## IMPORTANT DEALER SERVICE INSTRUCTIONS AND NOTIFICATION OF RECALL

**Service Communication:** 2007-003 USA Flag Designation

**Subject:** Recall Campaign 07V-254, Fork bottom yoke.

**Affected models:** 2003-2004 U.S. model years of Moto Guzzi California 1100 EV, California Stone 1100, California Aluminum 1100, California Titanium 1100 and California Special Sport 1100

**Illustration:**

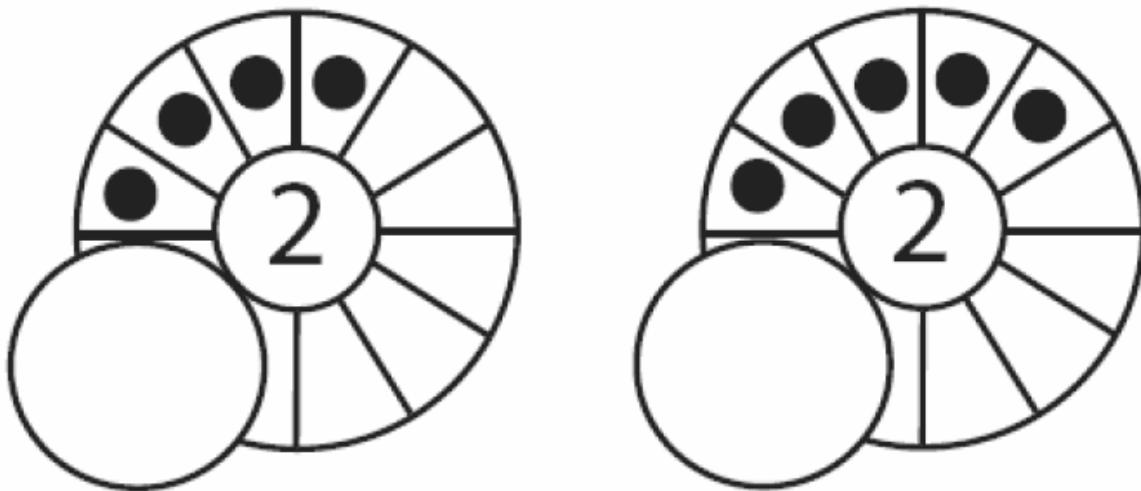
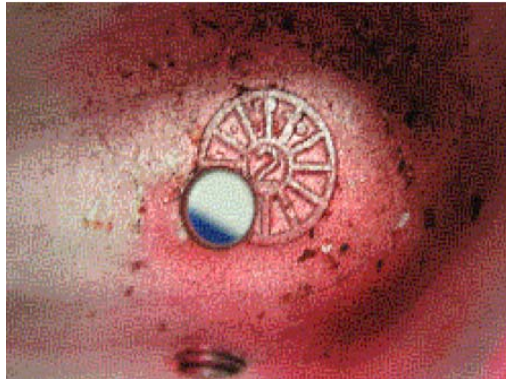
**Concern:** On some vehicles within the noted VIN range there exists the possibility that a crack may develop in the fork bottom yoke.

**Identification Procedure:** Vehicles on which this is possible may be identified by the production date stamp located on the underside of the fork bottom yoke casting. The date stamp identifies specific production information. This stamp is a circle with a number and a series of dots in a pattern. Only bottom yokes with the production date stamp of the number 2, with 4 dots, or the number 2, with 5 dots, need to be replaced. Please refer to the illustrations below to confirm the appearance of the production date stamp. If the bottom yoke is not marked as described above, replacement is not necessary. **Important Note: In the event that the date**

**stamp is difficult to read correctly, that is if the technician is unsure of the number of dots or their location on the date stamp, the fork bottom yoke is to be replaced.**

**Parts Information:** Vehicles affected by this recall will require a replacement fork bottom yoke, part number GU03494000 or GU03494045, depending on the model. A tapered roller bearing, part number GU92249225, will also be required.

**Important Note:** Tightening torque required for the steering bushing is **170 – 180 NM.**
